## Technical Memorandum No. 1 –

### Environmental Impact Statement Addendum

Proposed Site Redevelopment 200 Lees Avenue Ottawa, Ontario

The purpose of this technical memorandum is to provide specific responses to selected City of Ottawa Review comments on the EIS report provided to uOttawa on October 1, 2021.

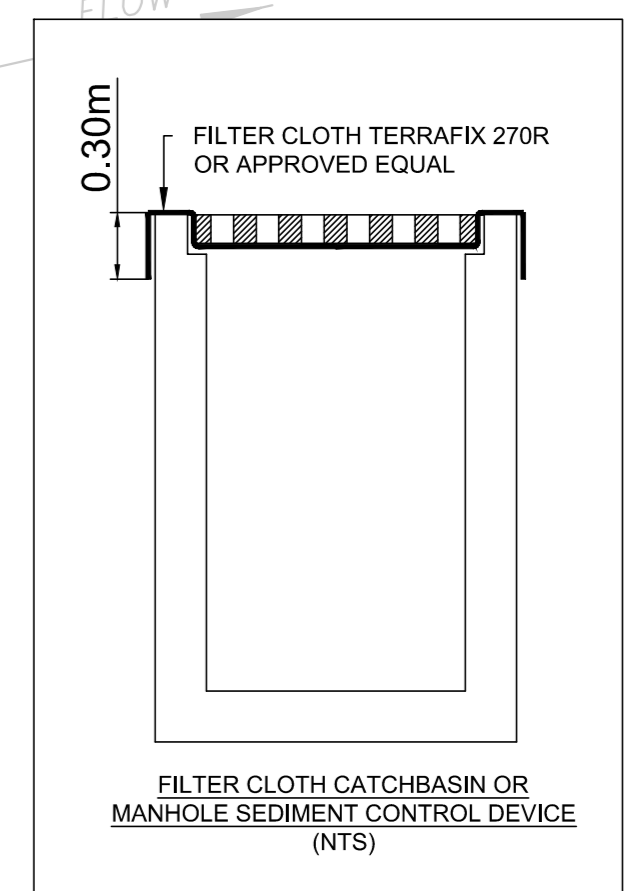
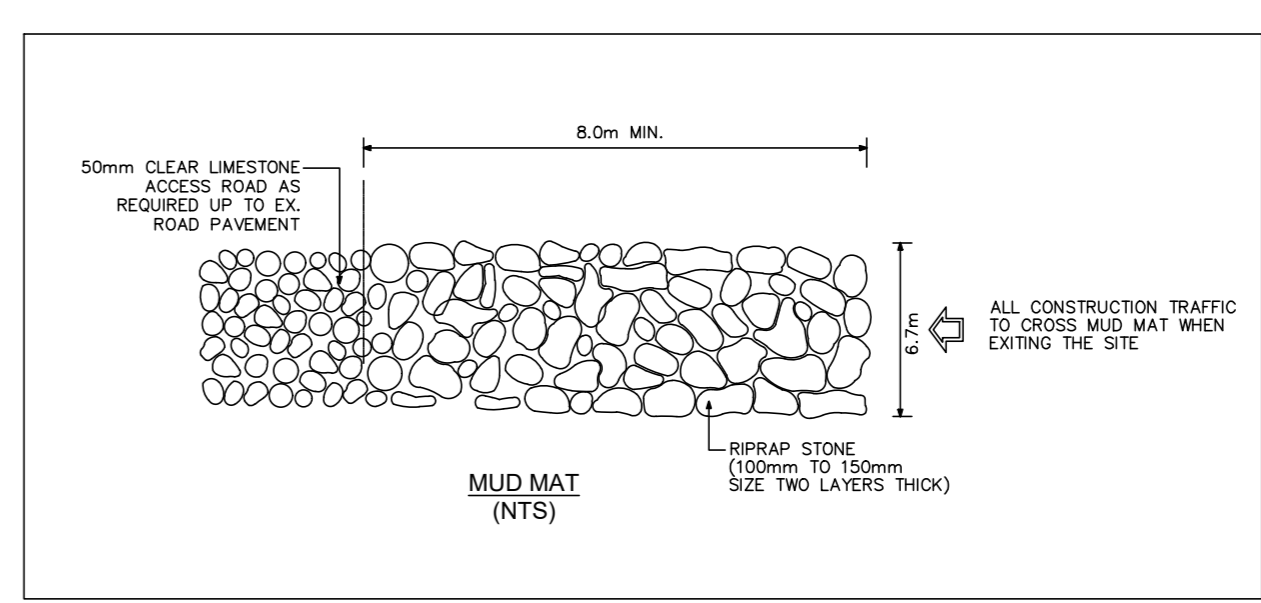
*c. Wildlife exclusion fencing should be provided along the boundaries of the site, at least along the watercourse side of the site. The fencing is best paired with the construction access fencing /erosion control fencing. We appreciate the approach of fencing/covering any stockpiles, however the entire side is a hazard for wildlife, particularly turtles, and access should be controlled, and this can be completed along with other fencing.*

Design and implementation of the proposed development were conceptual at the time of the completion of the EIS. Since the finalization of the report, further details have been confirmed. The Site is isolated by a 6' or 8' high fence around the perimeter of the construction site which is fitted with full height scaffold netting. Details are provided in the product information sheet in **Appendix B**. In addition to the perimeter fence the ESC plan (**Appendix C**) also entails a standalone silt fence, installed per OPSD 219.110 surrounding the site. The perimeter fence and silt fence together should be sufficient to prevent turtles and other wildlife from accessing the site.
